Before a Board of Inquiry  
MacKays to Peka Peka Expressway Proposal

Statement of rebuttal evidence of **Ann Williams** (Groundwater) for the NZ Transport Agency

Dated: 25 October 2012

-  Fill Embankment
-  Holocene Peat
-  Surcharged Peat
-  Drainage Layer
-  Marine Sands

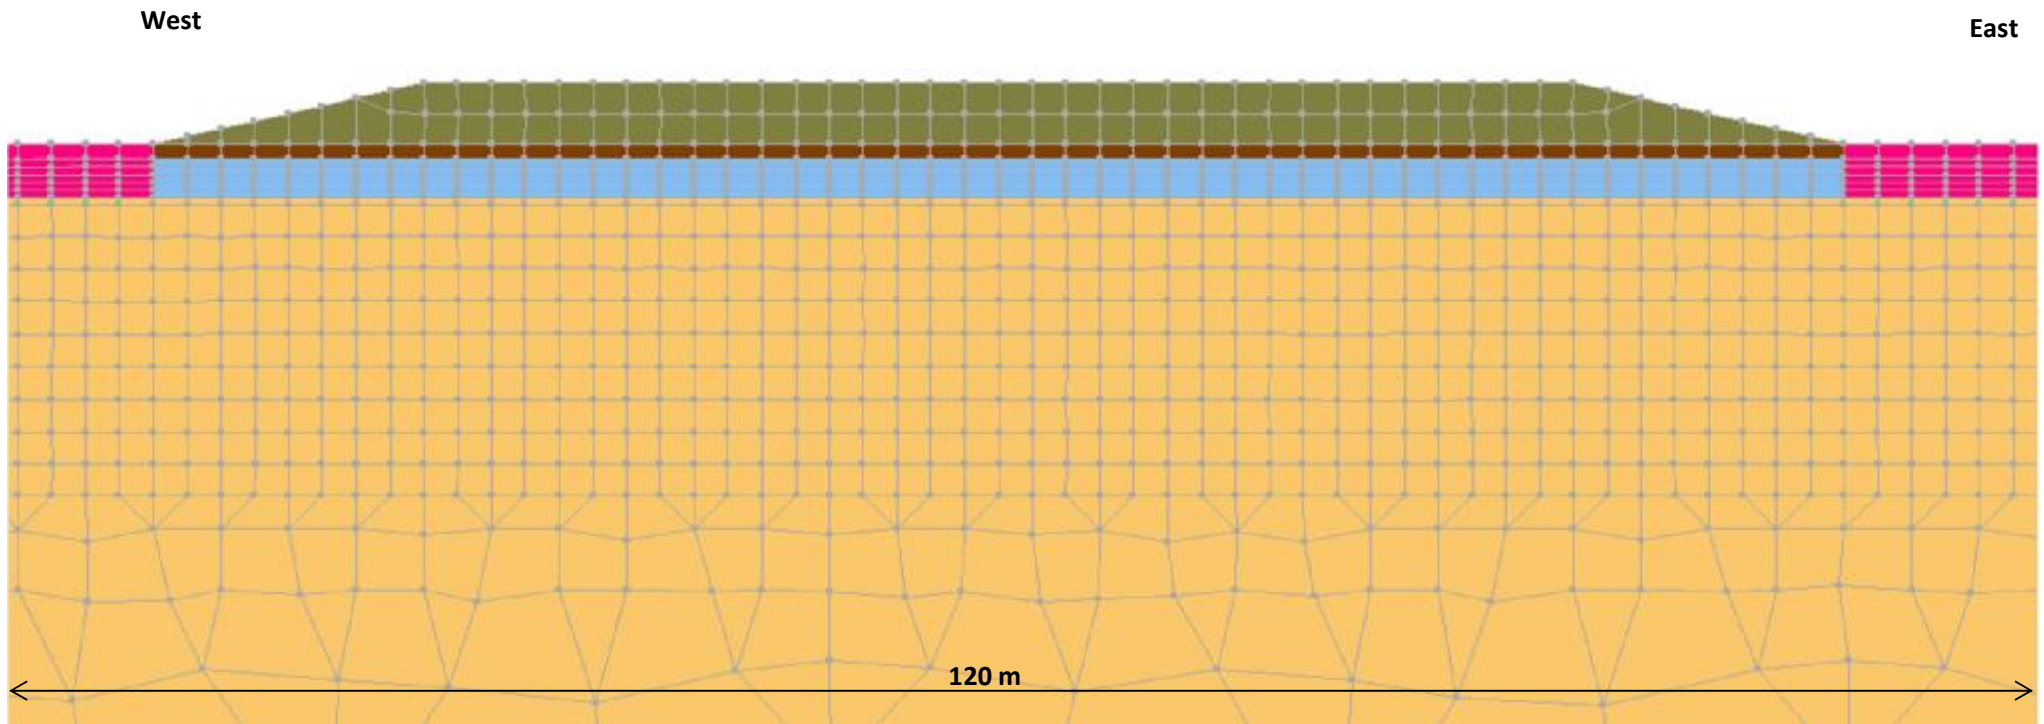
- 78 As Ms Rutter points out, there is an error in the labelling of the fill and greywacke in section CH5300 (Figure E1).<sup>65</sup> This is quite apparent but is corrected in **Annexure E** of this rebuttal evidence.<sup>66</sup>
